CALL NO. 103  
CONTRACT ID NO. 191027  
ADDENDUM # 1

Subject: CARTER COUNTY, STP 0071(028)  
Letting May 24, 2019

- (1) Revised - Proposal Bid Items - Pages 108-111 of 111
- (2) Revised - Plan Sheets - T1, X13, X14, X15, X35, X36, X44, X45, X46, X47, X48, X49, X50, X51, and X52

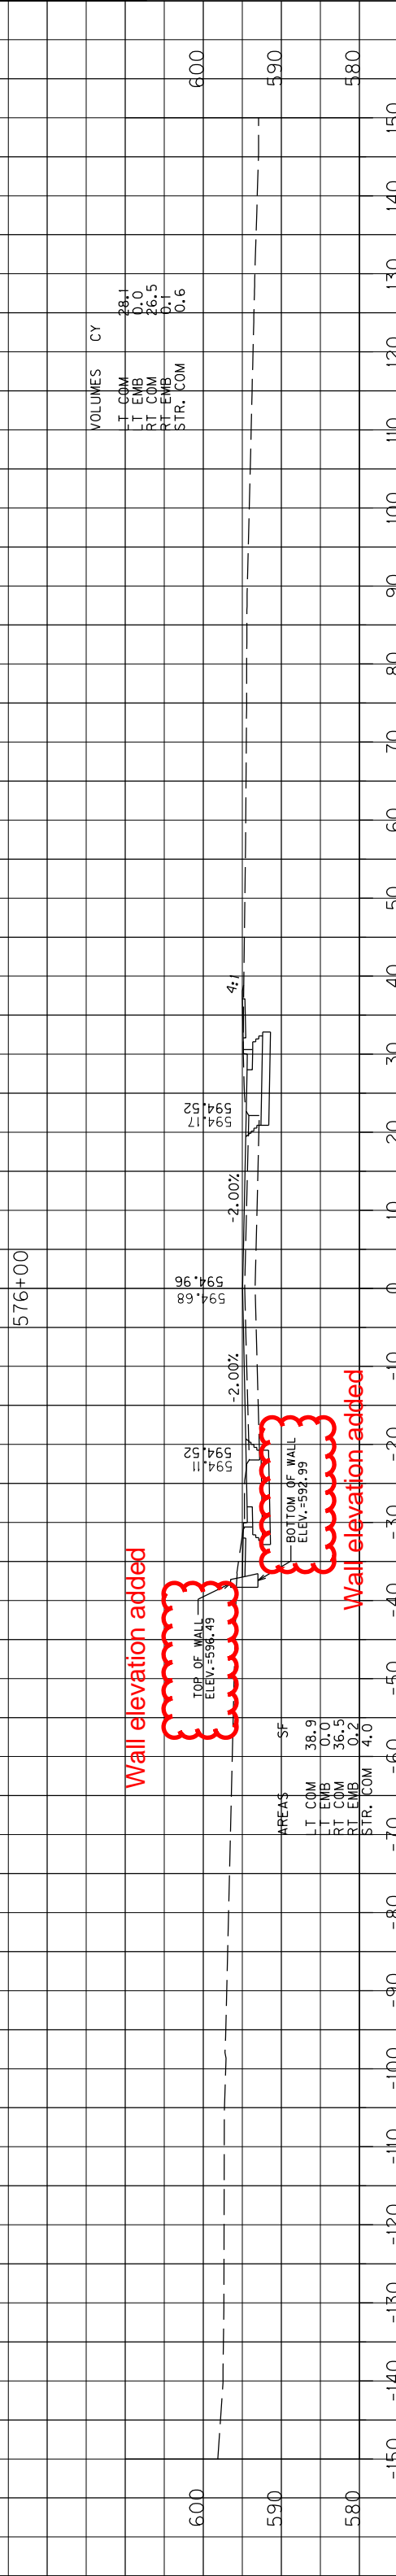
Wall elevation added

TOP OF WALL  
ELEV.=598.49

BOTTOM OF WALL  
ELEV.=592.99

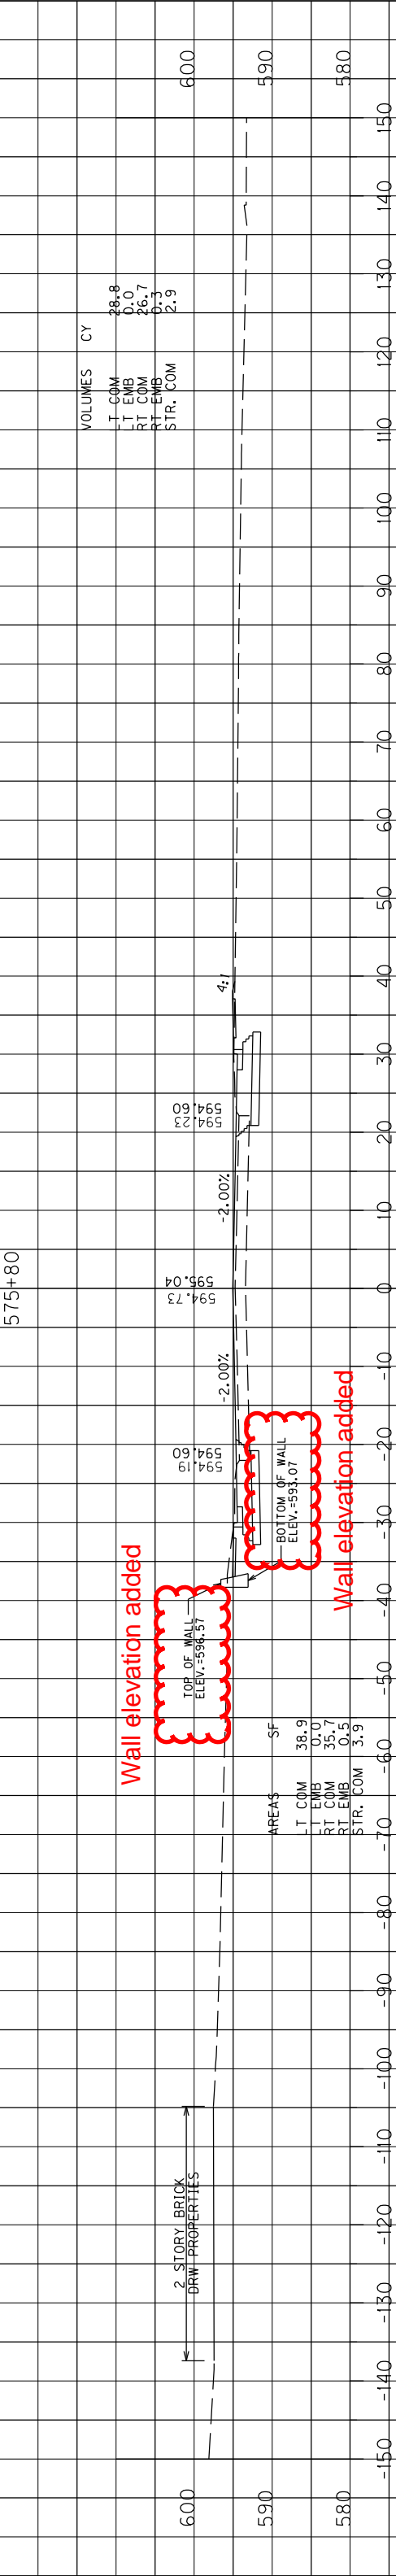
Wall elevation added

TOP OF WALL  
ELEV.=598.57

BOTTOM OF WALL  
ELEV.=593.07

598+40

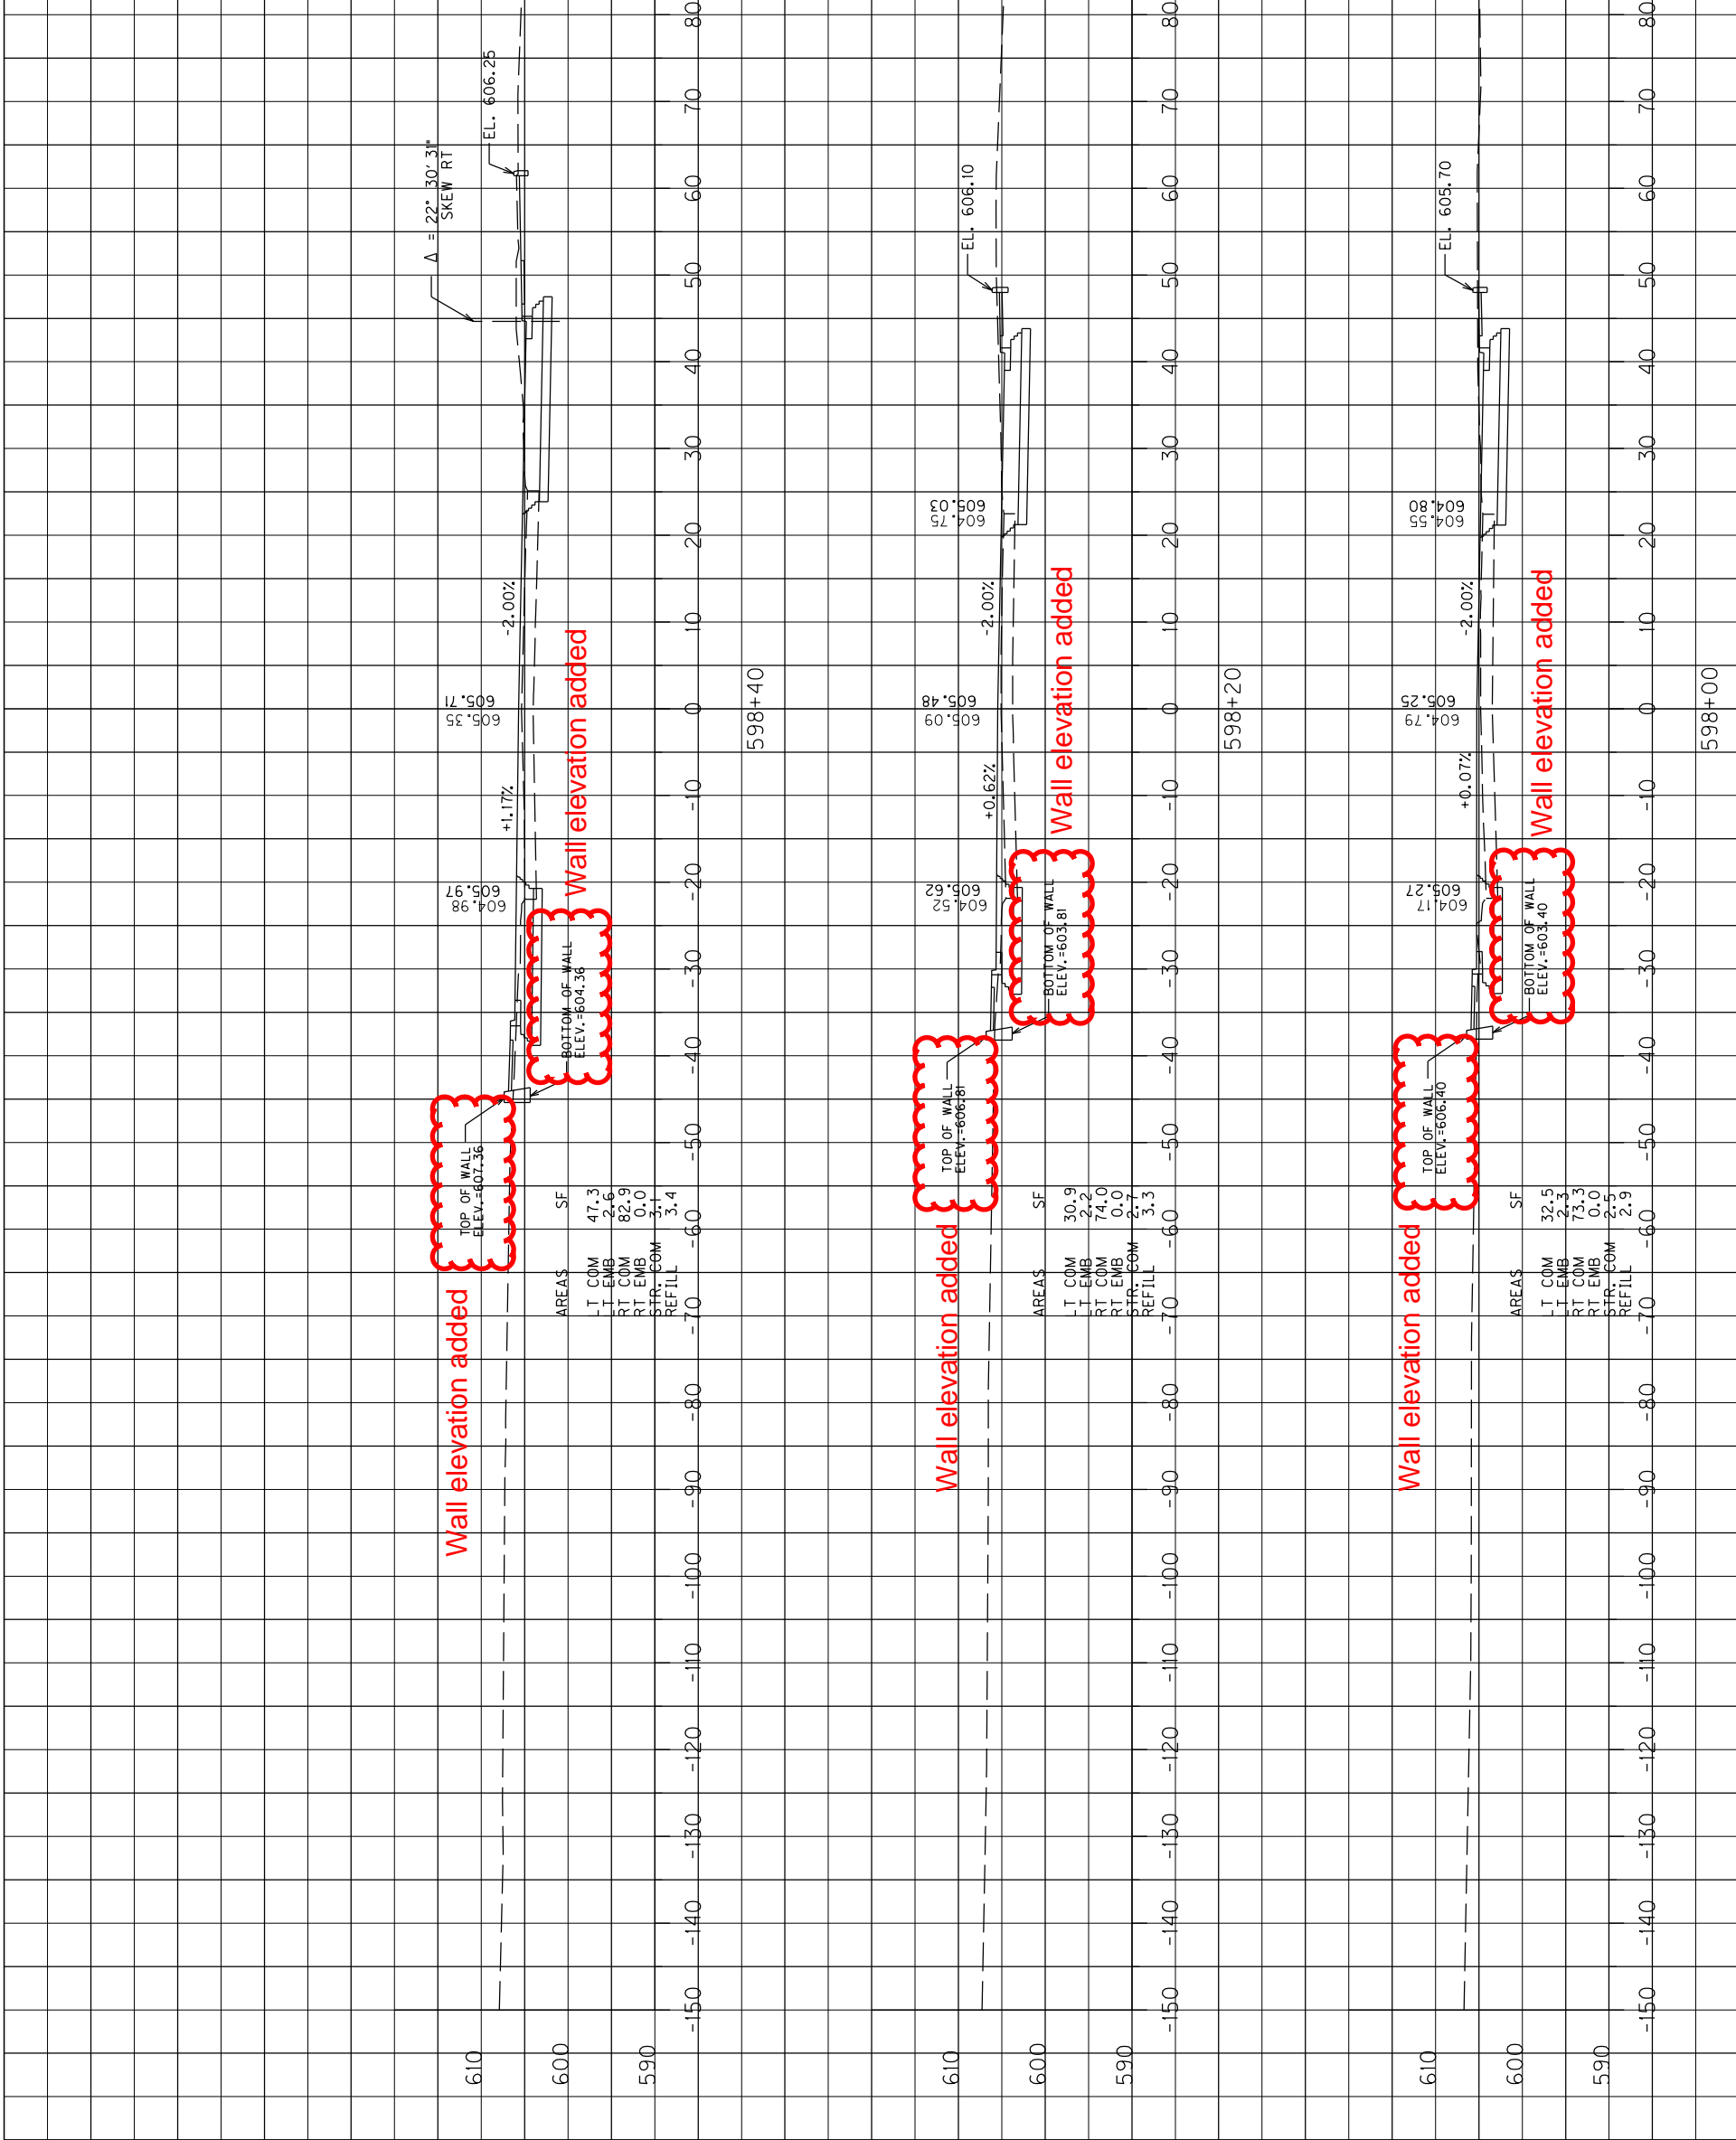
Wall elevation added

TOP OF WALL  
ELEV.=607.36

BOTTOM OF WALL  
ELEV.=604.36

Wall elevation added

TOP OF WALL  
ELEV.=606.81

BOTTOM OF WALL  
ELEV.=603.81

Wall elevation added

TOP OF WALL  
ELEV.=606.40

BOTTOM OF WALL  
ELEV.=603.40
